Client: Northvale County Council
Designer: Arden Moss Consulting Engineers
Kestrel Valley Link Road
River Kest Bridge East Abutment General
Arrangement
Drawing number: KVL-ADM-410-DR-S-0102
Revision: P03 Status: FC - For construction
Scale: 1:100 @ A1 Date: 2 October 2025
Drawn: LC Checked: PN Approved: DO

PLAN ON EAST ABUTMENT

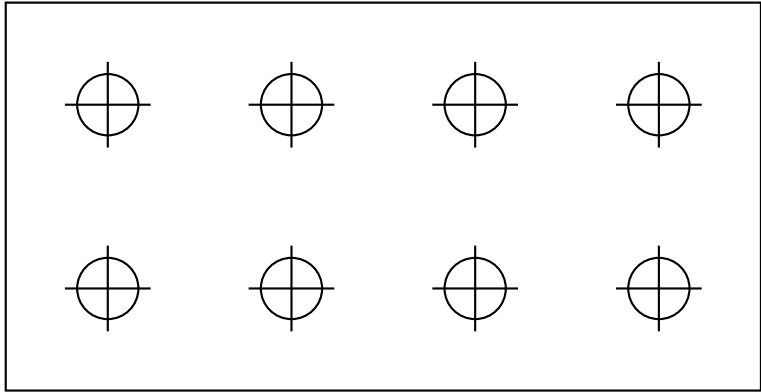
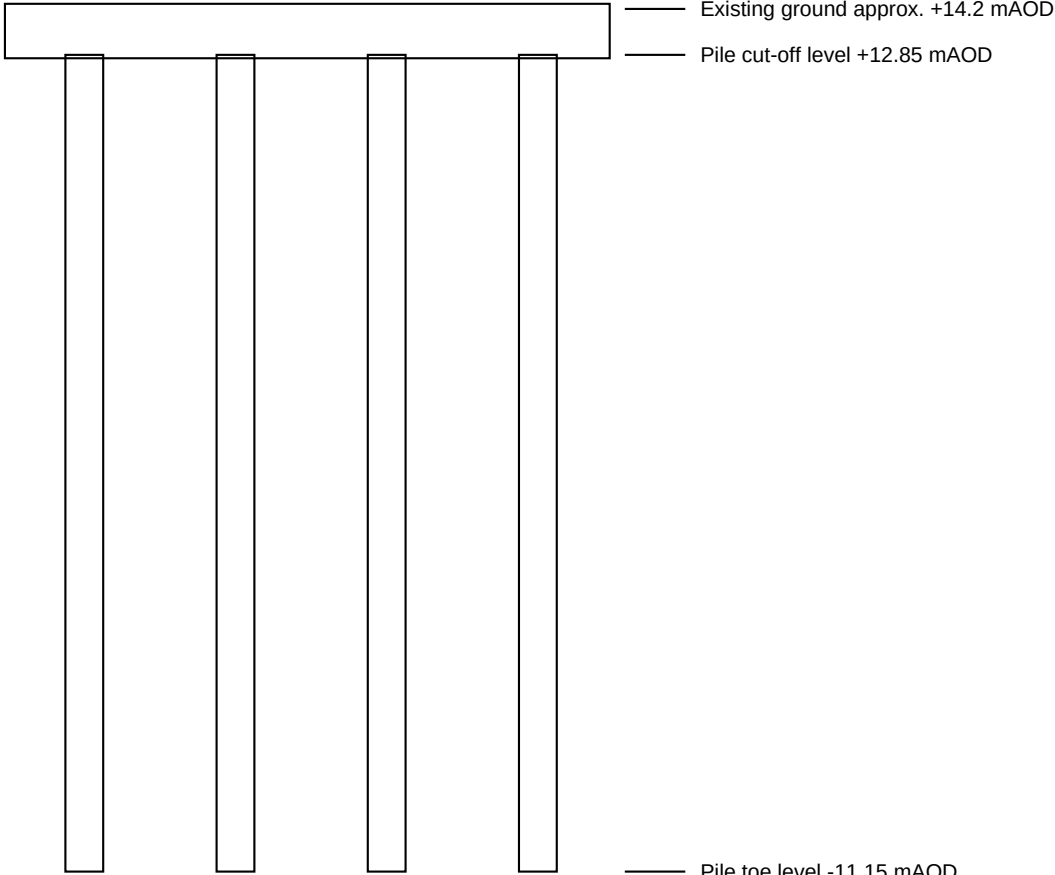
- NOTES**
- 1. Proposed change - weep holes replaced by a geocomposite drainage layer.
 - 2. Issued for comment only. Revision C02 remains the construction issue.
 - 3. Piles unchanged from revision C02.
